OFFICIAL MINUTES
SUMMERSET PLANNING AND ZONING COMMISSION
REGULAR MEETING
TUESDAY, MARCH 24th, 2026 @ 6:00 P.M.

Date: Thursday, March 12, 2026
Project: Lots 28-47 of Block 4, Common Lot 1 & Lots 4-12 of Block 5, Lots 1-35 of Block 6 Macallan Way, Macallan Court, Caledonia Way, Caledonia Court, & Kilted Court Right-of-Ways & Major Drainage Easement, Norman Ranch Subdivision
To: Lisa Schieffer, City Administrator
From: HDR, Inc
Subject: Preliminary Plat & Construction Plan Review

A resubmittal of the Norman Ranch Subdivision Phase 1b plan and plat documents dated February 26, 2026, has been received and reviewed by HDR. The previous submittal review comments are below with updates from the most recent review. Prior comments that have been adequately addressed were retained but text has been struck through to indicate resolution.

NORMAN RANCH PHASE 1 & 2

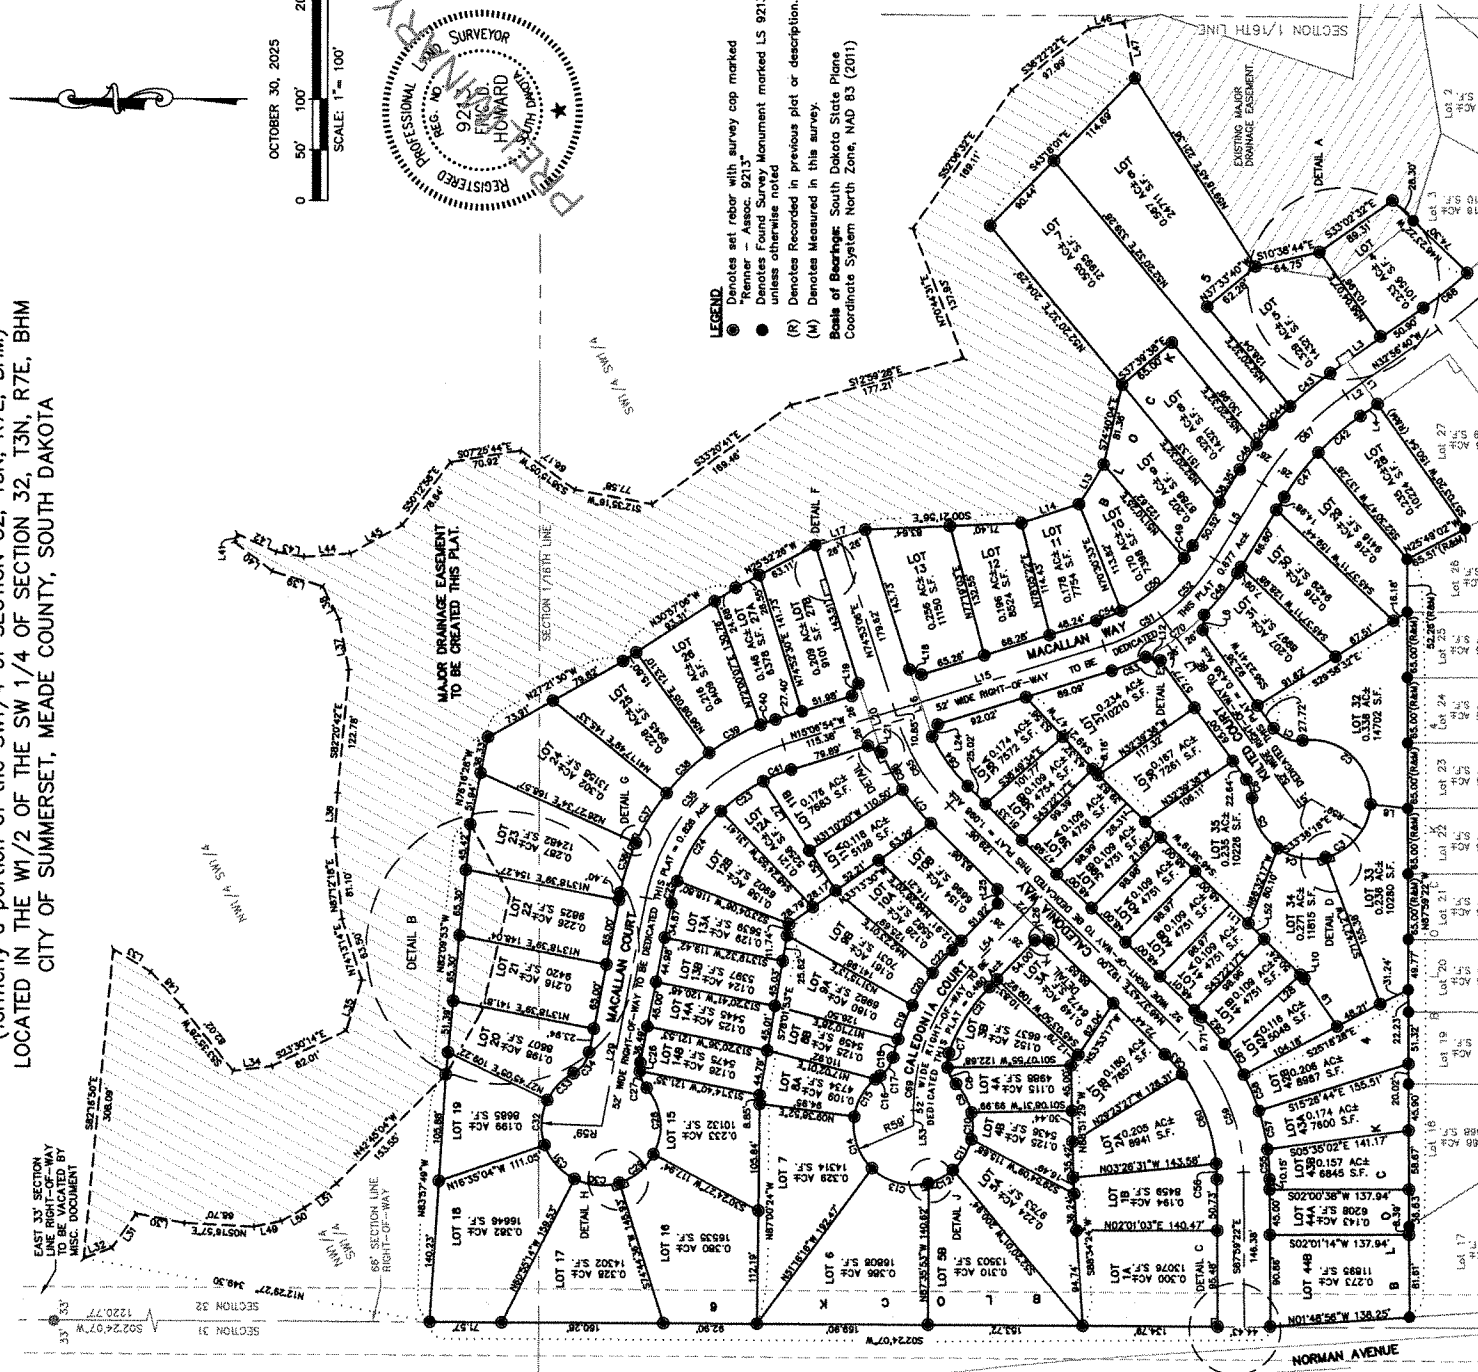
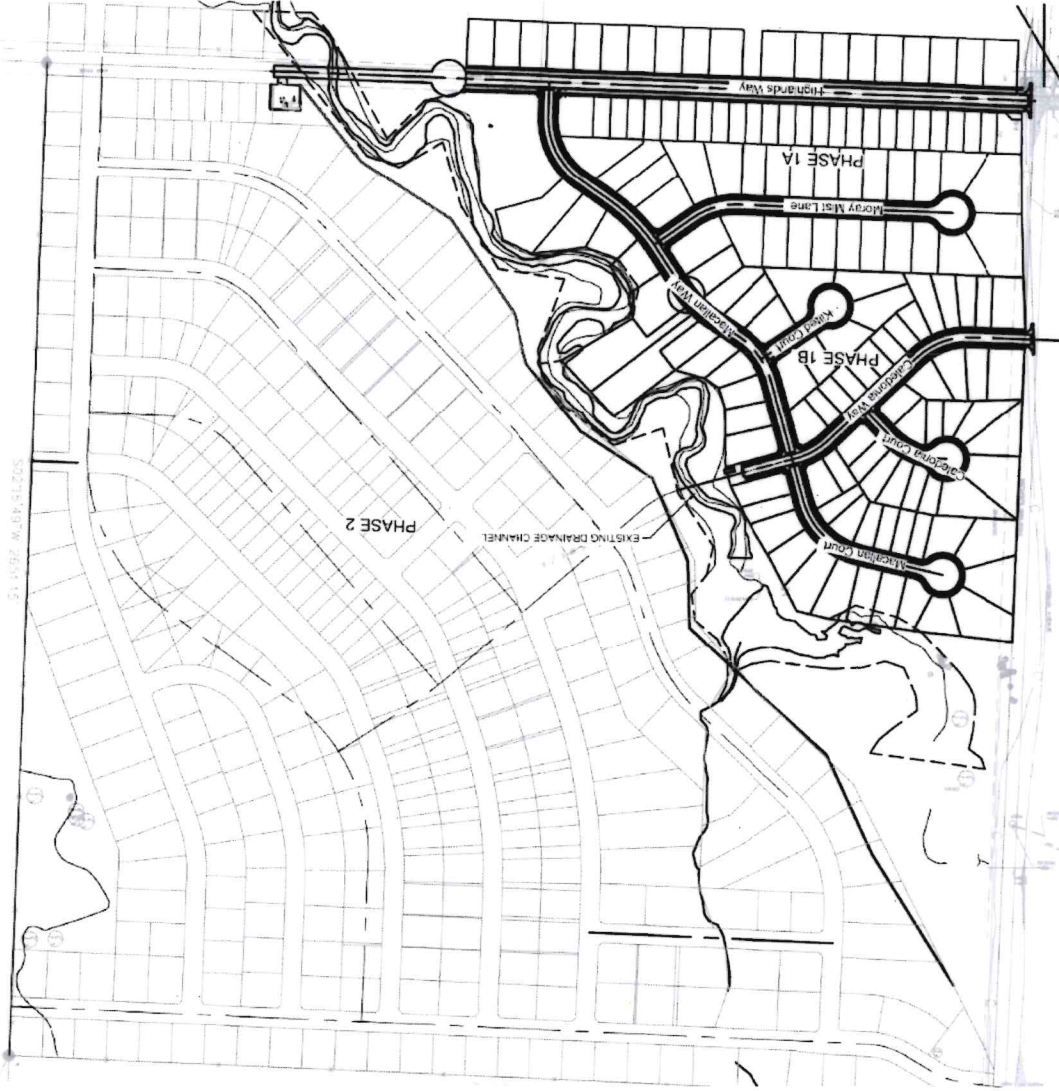
1. ~~Check boundary bearings and distances on the parcels north of Caledonia Way and the major drainage easement. They don't close.~~
2. ~~Macallan Court design exception request was denied but still shows 22 lots. Driveways of Lots 11A and 27B must be fed off of Caledonia Way, or a design exception request must be submitted.~~
3. ~~Edit text color for Lot 4 and Lot 6, Block 5 to black.~~
4. ~~Add bearing for southeast (28.30') and northwest (50.90') lot line of Lot 4, Block 5.~~
5. ~~Need to provide bearing and distance for line L1.~~
6. ~~Cleanup bearing text on the north lot lines for Lots 23 and Lot 24, Block 6.~~
7. ~~Add bearing and distance for northwest lot line on Lot 19, Block 6.~~
8. ~~Closure check was not finished due to missing bearing and distance information.~~

1. City has previously indicated they want major drainage easements platted outside of home lots, please reconfigure Lot 4 and Lot 5, Block 5 and Lot 20, Lot 21, Lot 22, and Lot 23, Block 6 to be platted not within major drainage easements.
2. City has allowed "flag" lots like Lot 6 and Lot 7, Block 5, but has not liked how they end up once houses are constructed. Please reconfigure area to not have flag lots.

1. Plat closure was not able to be obtained with provided CAD file. The following updates should be made for plat closure:
 - a. Curve C33
Delta – 36°34'29"
Chord Direction - N 43° 57' 54" W
Chord Length – 37.03'
 - b. Curve C34
Radius - 29.99
Chord Direction - N 51° 11' 32" W
 - c. Curve C66
Chord Direction - N 63° 08' 04" W
Chord Length – 42.31'
 - d. Curve C71
Chord Direction - N 52° 11' 45" E
 - e. L20
Length – 73.03
Direction – N 73° 41' 35" E
 - f. The distance on the NE lot line of Lot 4 Block 5 should be 88.61'
 - g. The bearing for the ROW line in Detail C on the SE line (7.59' line) should be N 01°48'56" W

- 1. Section line vacation is needed along west end on phase 1b.
- 2. Grading permit has lapsed. New permit required.

✓
Taken care of
5/6/2026
